TEXAS COMMISSION ON ENVIRONMENTAL QUALITY

Name of Project: **Central Texas Pain Center**; Located at 213 Hunter's Village; New Braunfels, Texas

Type of Plan: Request for Technical Clarification of an Approved **Water Pollution Abatement Plan**; 30 Texas Administrative Code (TAC) Chapter 213, Edwards Aquifer

Re: Response to TCEQ Comments dated June 23, 2014
Edwards Aquifer, Comal County
NAME OF PROJECT: Hunter's Creek Business Park, Lot 11B2; Located on the north side of Hunter's Village, approximately 150 feet northwest of the intersection of Hunter's Village and Oak Run Parkway; New Braunfels, Texas.
TYPE OF PLAN: Request for Approval of a Water Pollution Abatement Plan; 30 Texas Administrative Code (TAC) Chapter 213 Edwards Aquifer;
Additional ID No. 13-14052001; Investigation No. 1172139; RN107296733;

TCEQ AREA EXHIBIT

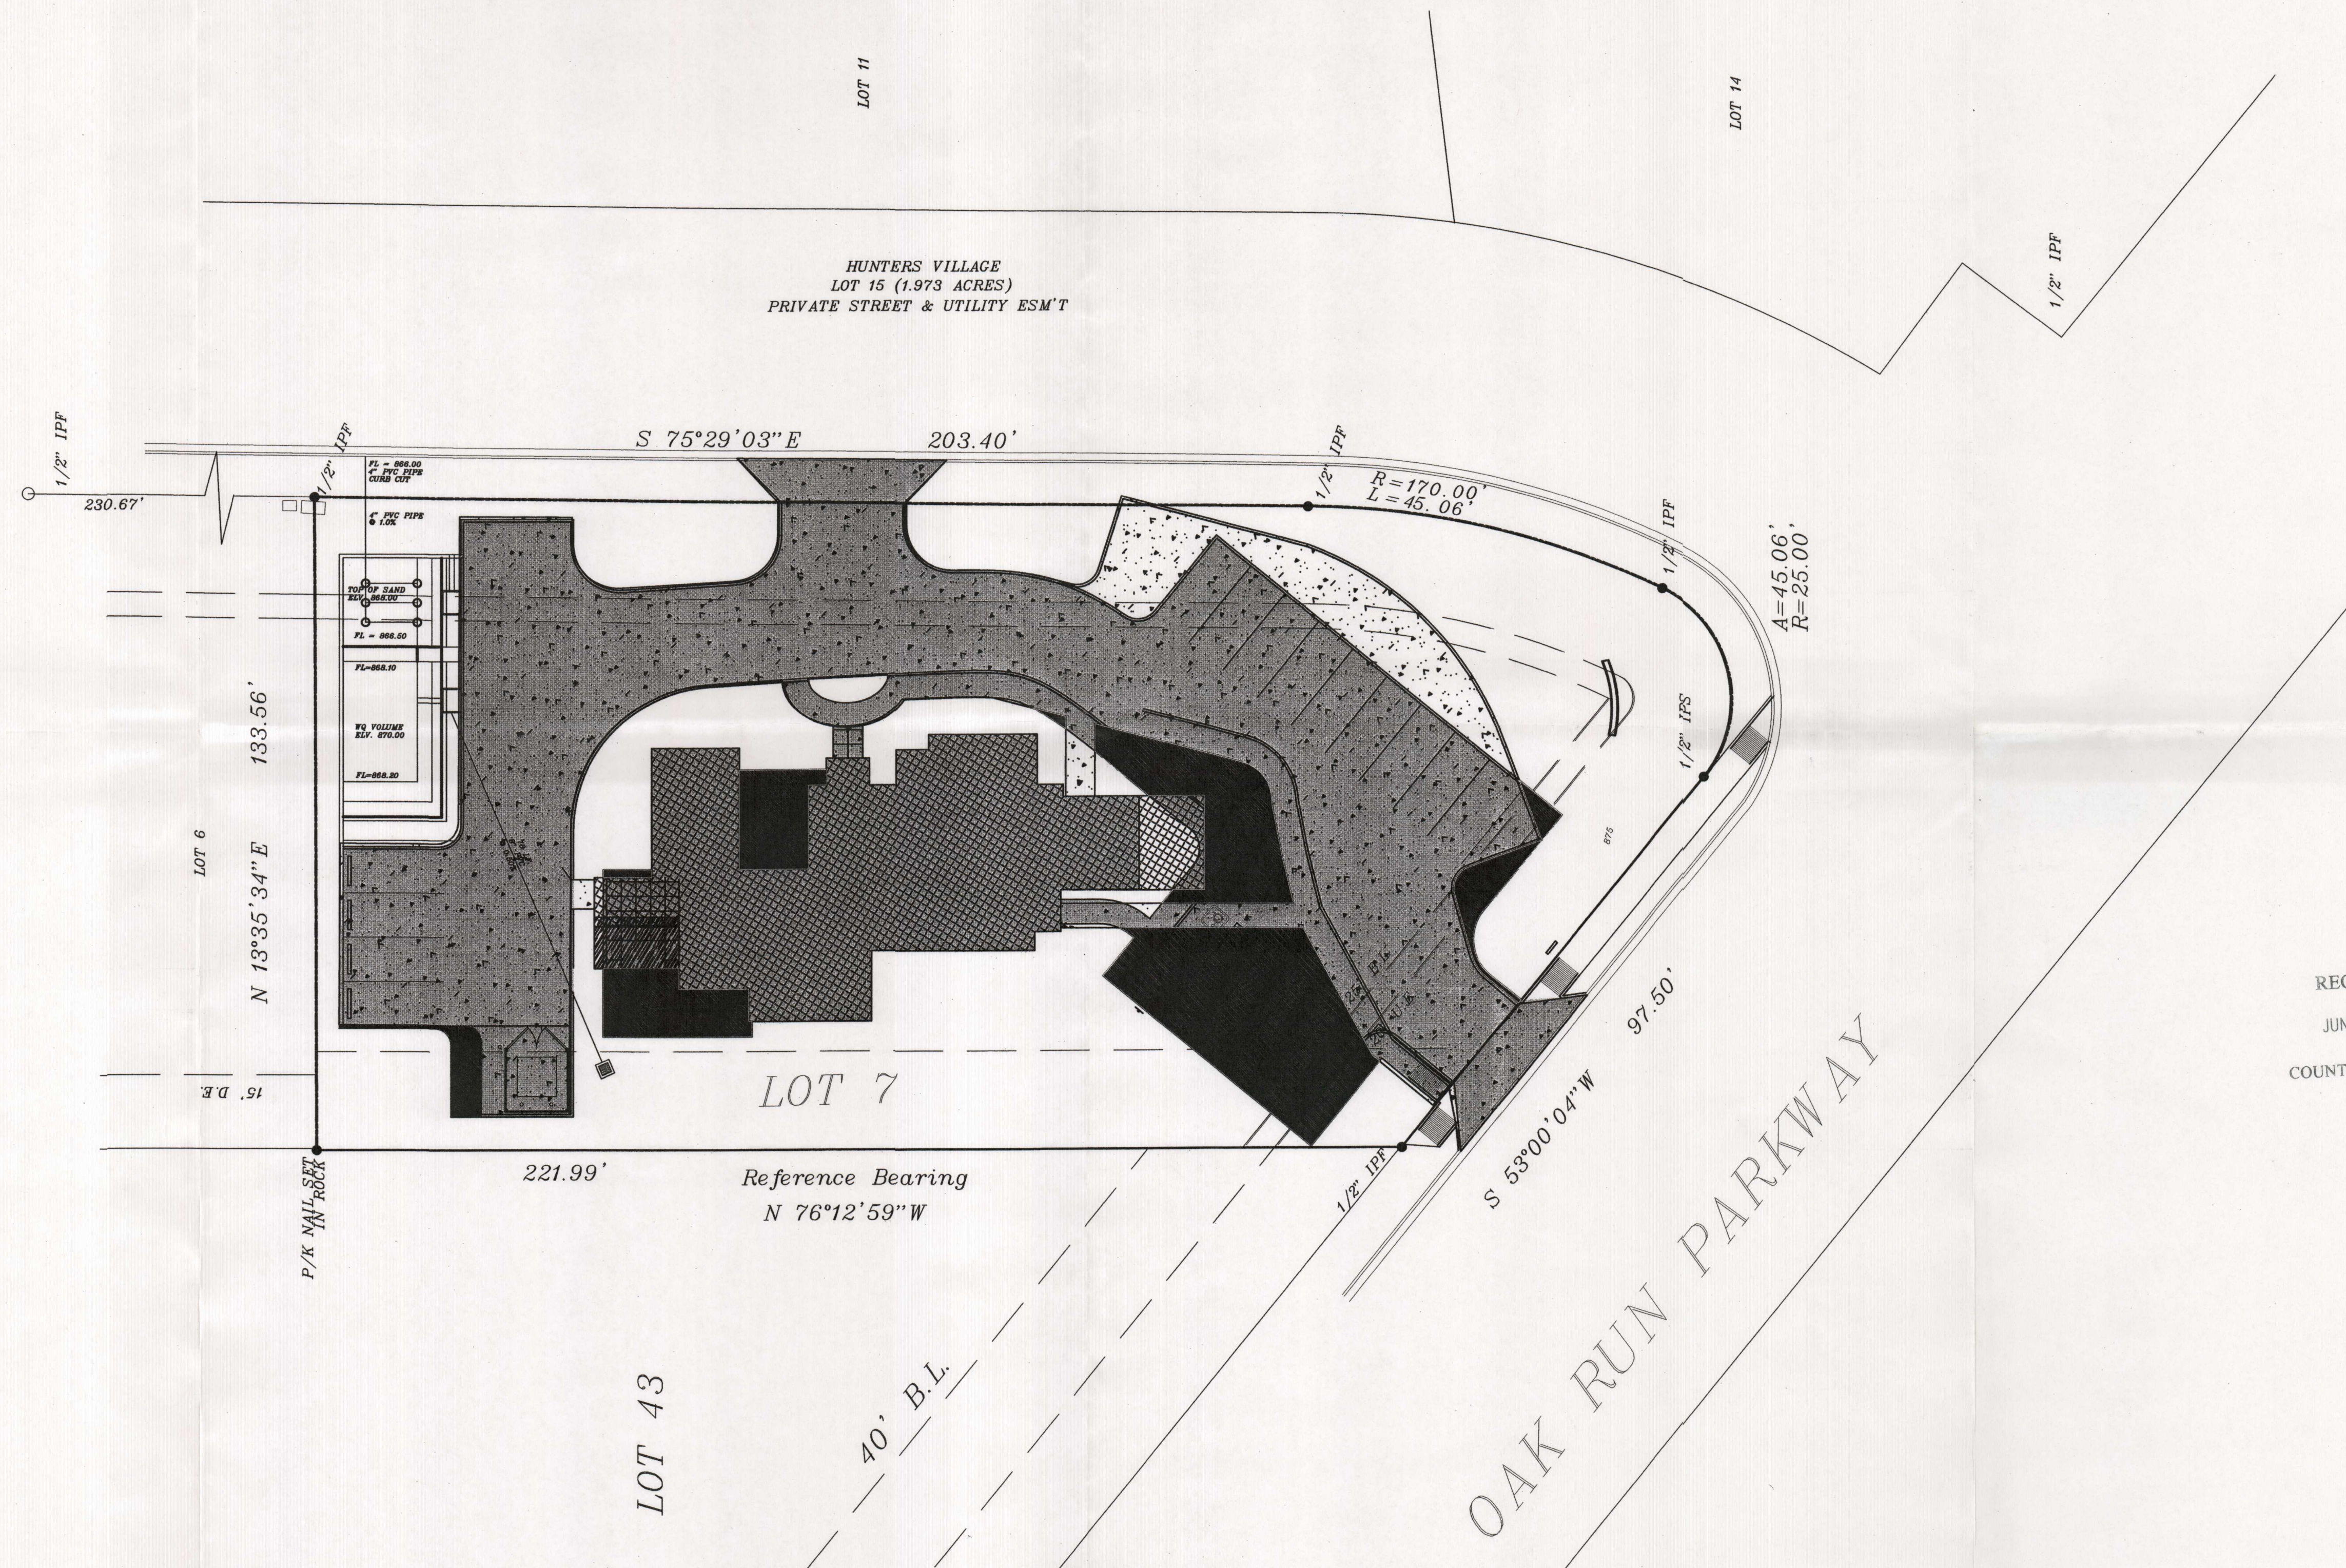
Since its approval, the owner constructed a total of 0.3926 acres of impervious cover. Enclosed is an exhibit of the existing impervious cover of the site. Shown also on the exhibit are areas that remained pervious since the WPAP was approved. The additional 140 square feet of office space will bring the total impervious cover to 0.3956 acres.

GRADING
PLAN

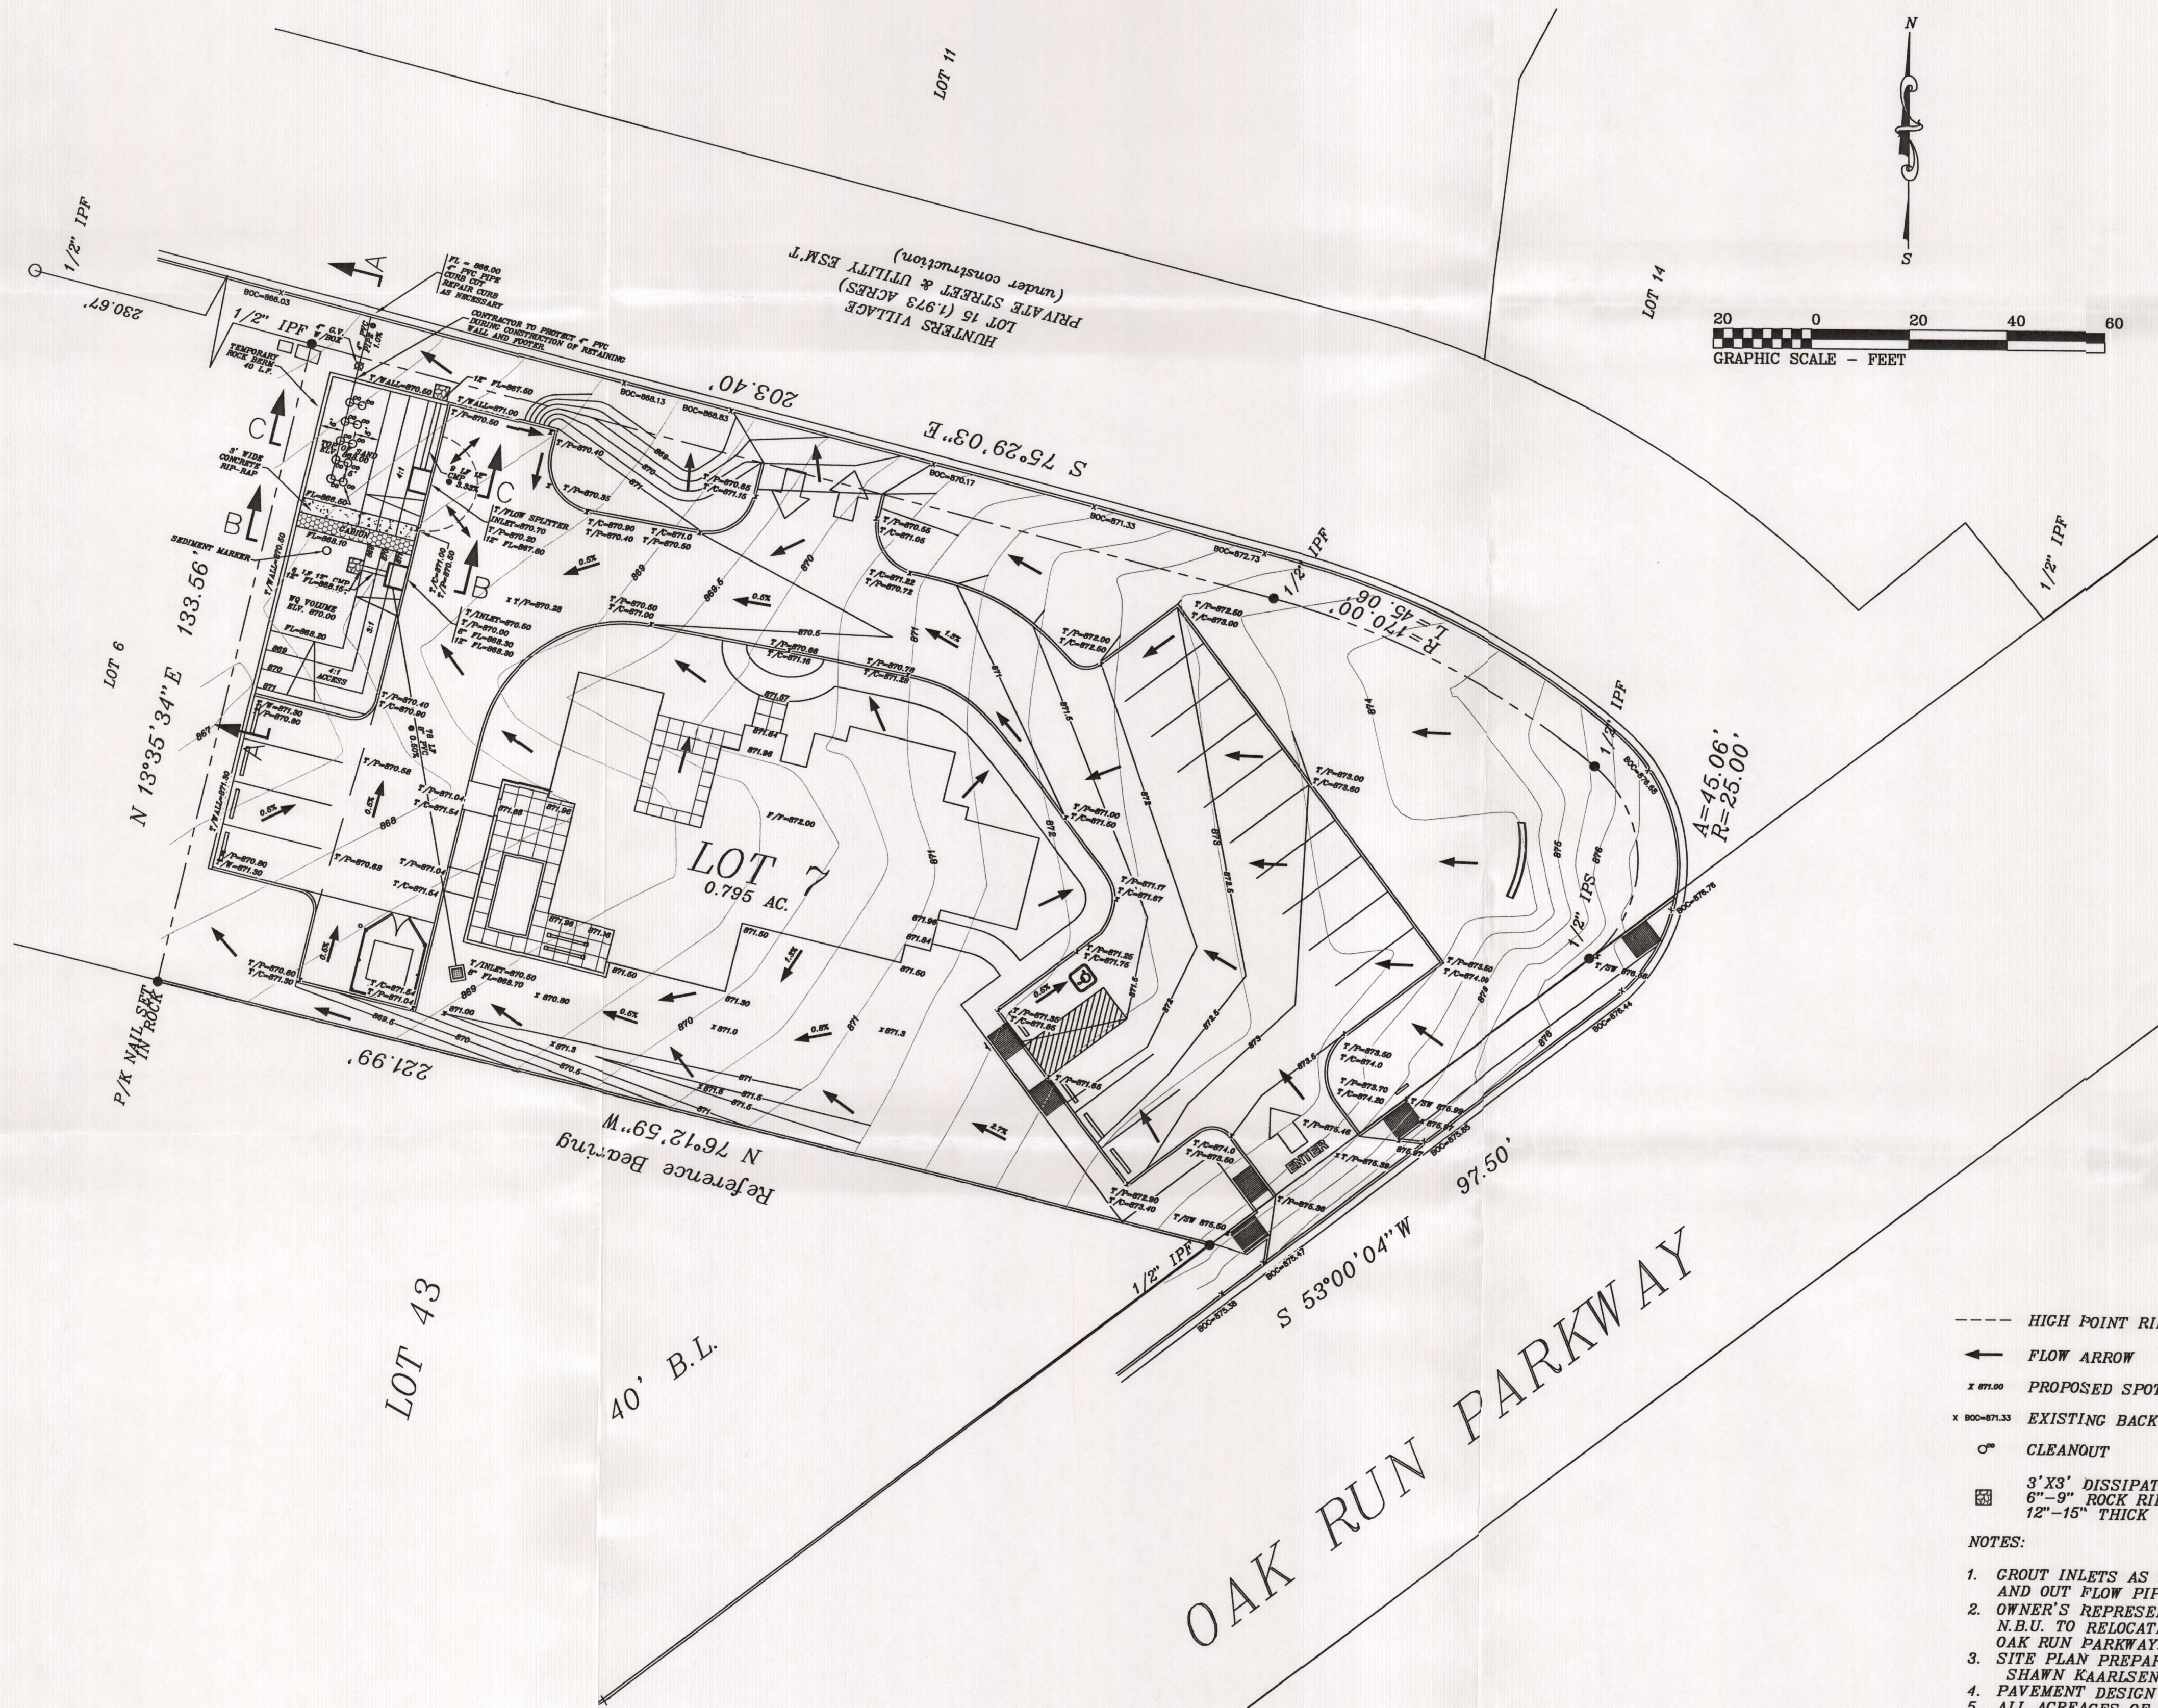
1. It is unclear how stormwater runoff from the northwestern portion of the site, next to the basin, will drain into the basin. It appears that stormwater from the uncaptured area will flow into the bypass inlet and therefore bypass treatment (see Attachment A). Please address this issue and amend site plan and/or calculations as necessary.
2. To better evaluate the directional flow of stormwater to the basin, please amend Sheet C4 to include finished contours.
3. It appears that the driveway apron, located on Oak Run Parkway, is an uncaptured area and was not accounted for in the calculations (see Attachment B). Please amend site plan and calculations as necessary.

1. Please see the revised site plan. We have raised the bypass curb inlet to a higher elevation to prevent stormwater from entering into this inlet until the pond is full and backs up slightly into the parking lot. We have provided more spot elevations and a detail to show that the parking lot will act as a weir. We apologize for the confusion regarding the previous comments. There is no designated parking spot in the area directly in front of the bypass inlet. This is not a high traffic area. Therefore, there is limited opportunity for contaminants to enter the bypass inlet. The pond was increased in size to account for this area and the driveway apron area on Oak Run Parkway, as you can see in the revised calculations.
